SERVICE BULLETIN

Classification: EC13-013a	Reference: NTB13-102a	Date: October 23, 2014
------------------------------	--------------------------	---------------------------

2012-2013 NV; MIL ON WITH DTC P0448

This bulletin has been amended to include a procedure to replace the vent tube filter, and provide a part number and claims information. Please discard the previous version

Figure 1

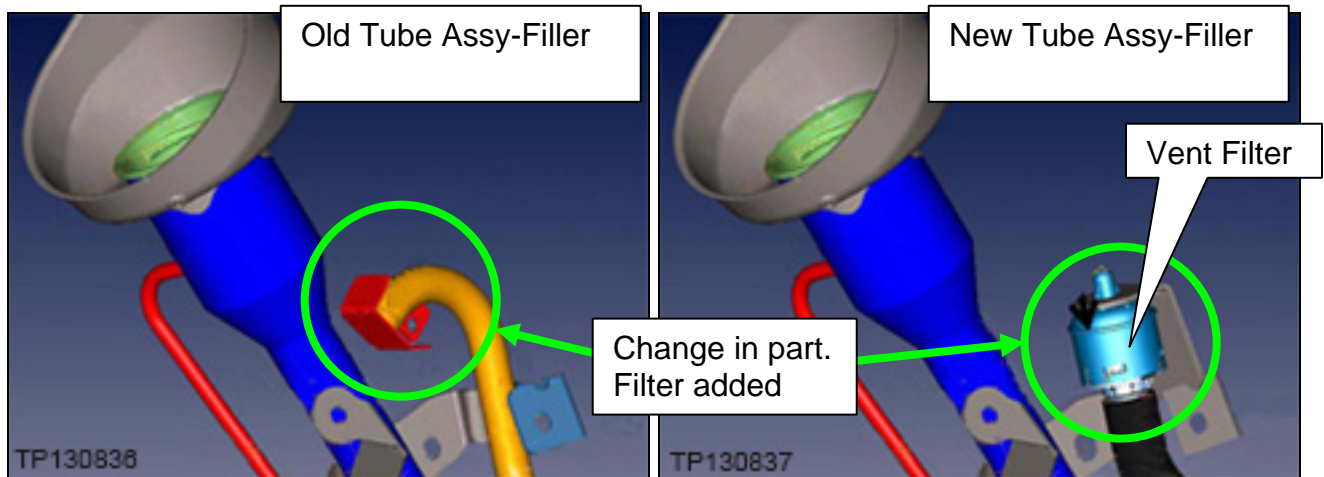
Confirm that the Tube Assy-Filler is the updated part as shown in Figure 2.

- If the Tube Assy-Filler is the old style as shown in Figure 1, replace it with the Tube Assy-Filler (Figure 2) from the Parts Information on the next page.
- If the Tube Assy-Filler is the new style as show in Figure 2, replace only the “Vent Filter” also shown in Figure 2 with the procedure on page 2.

Figure 1

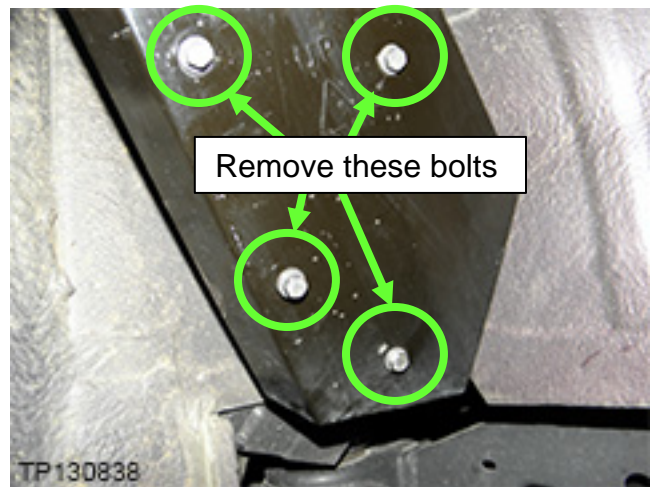
1. Remove the 4 bolts that attach the guard plate and then remove it.

Figure 2

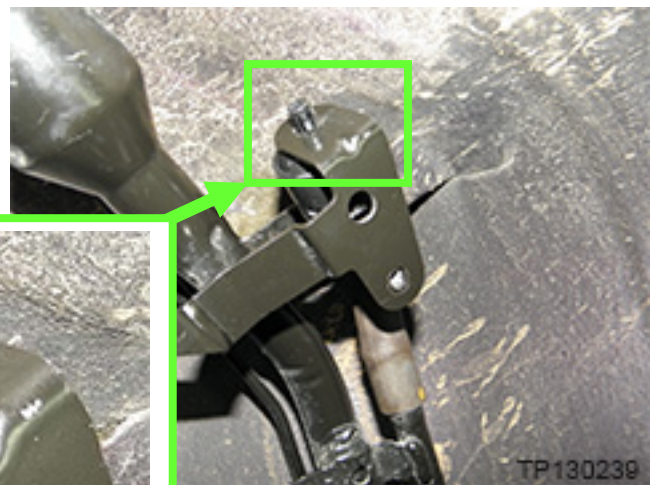
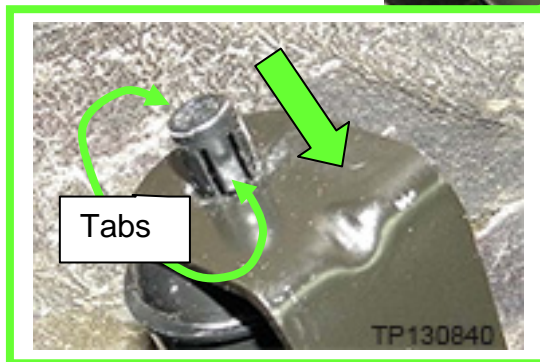
2. Remove the filter from the bracket:
 - a. Depress the two tabs.
 - b. And then push through bracket.

Figure 3

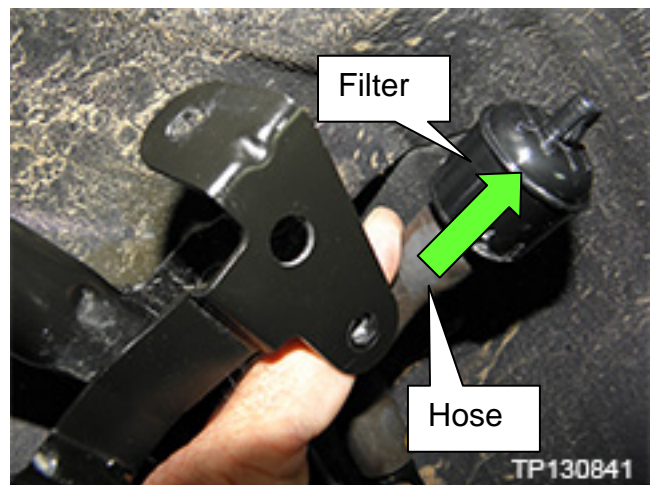
3. Remove the filter from the hose.
4. Reassemble with new the new filter from the part information table in the reverse order.
